☐ Oil Well ☒ Gas Well ☐ Other8. Well Name and No.  
JERVIS AYB FEDERAL 7

Yates petroleum Corporation plans to plug and abandon this well as follows:

Wellbore schematics attached

WELL NAME: Jervis AYB Federal #7 FIELD:

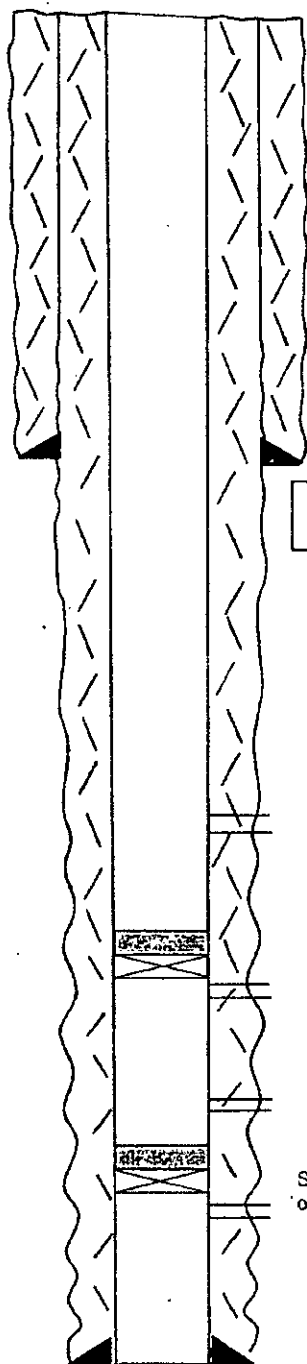
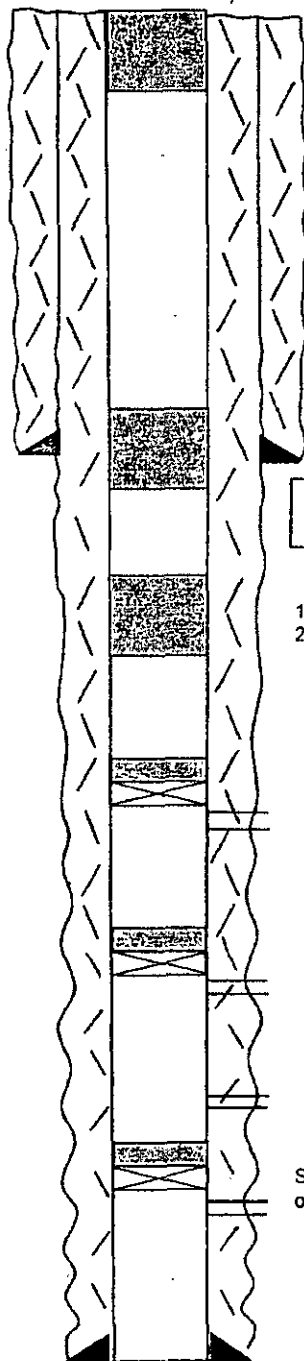
110' (25sx) class "C" cement plug from 1076'-1186' covering the 9-5/8" casing shoe.

90' (10sx) class "C" cement plug from 90' to surface. This is the surface plug.

120' (25sx) class "C" cement plug from 2044'-2164' covering the top of the Glorieta

Abo perms @ 4418'-4764'. CIBP @ 4372' w/ 35' of cement on top covering the top of the Abo.

3. Spot a 25 sx Class C cement plug from 2044 ft - 2164 ft. This will cover top of Glorieta. **WOC & Tag Or Above 2044 Ft**
